ENVIRONMENTAL COMMITTEE MEETING

January 7, 2026

Subject: Review of redevelopment plans for 424 Butler Ave. E.

PROJECT
BUTLER AVE DEVELOPMENT

DRAWING N°
 C-5

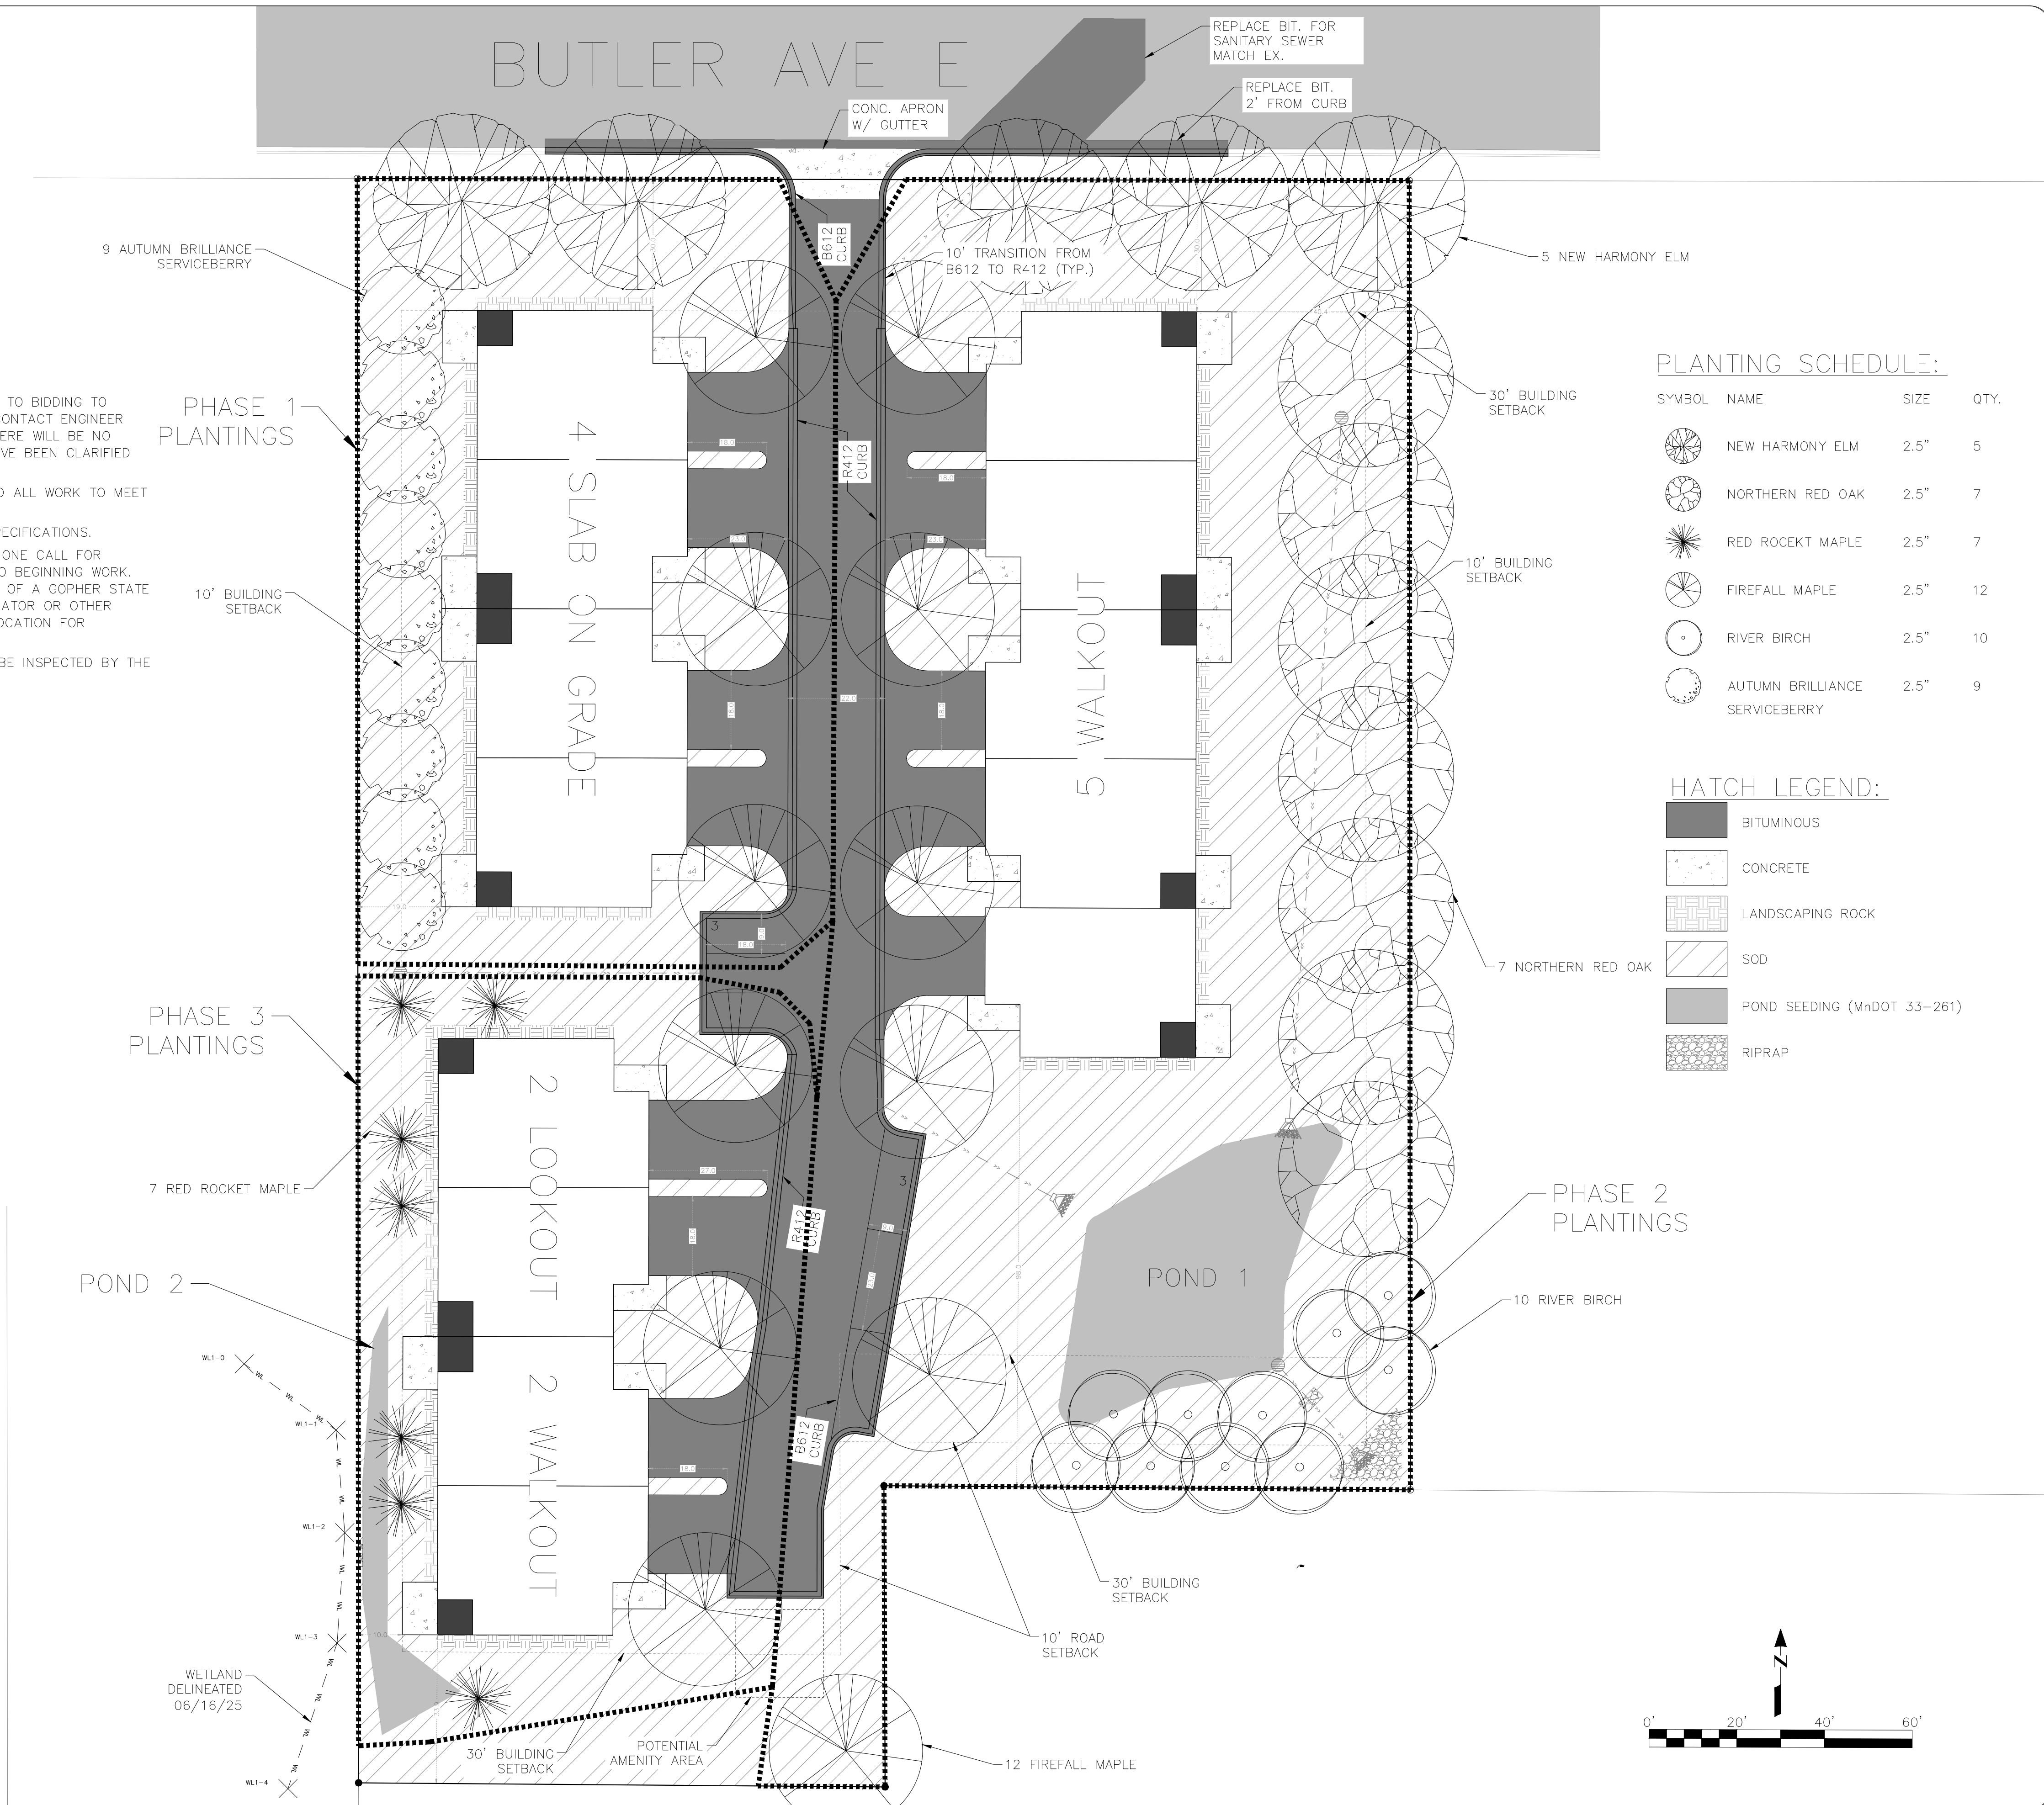
The list below includes the initial proposal for new plantings on the site. Staff has crossed out the initially proposed plantings (shown by the ~~double strikethrough~~) and added alternative plantings in red text as well as recommended additional plantings.

Staff is also recommending that the size of trees be increased from 2.5 caliper inches up to 3 inches. This brings the number of proposed trees/caliper inches for the site to 57 trees and 171 caliper inches. As these numbers fall below the minimum requirement (144 trees/359 inches), staff is requesting feedback from the commission on where additional trees might be planted as well as recommended types.

- All trees are to be increased in size from 2.5 caliper inches to 3 caliper inches.

- The seven Northern Red Oak trees are to be replaced with three Bur Oak and four Swamp White Oak trees.
- The seven Red Rocket Maple trees are to be replaced with three Common Hackberry and four Honey Lotus trees.
- The 12 Firefall maple trees are to be replaced with six Black cherry and six Little Leaf Linden trees.
- The plans shall include an additional seven Red Cedar trees.
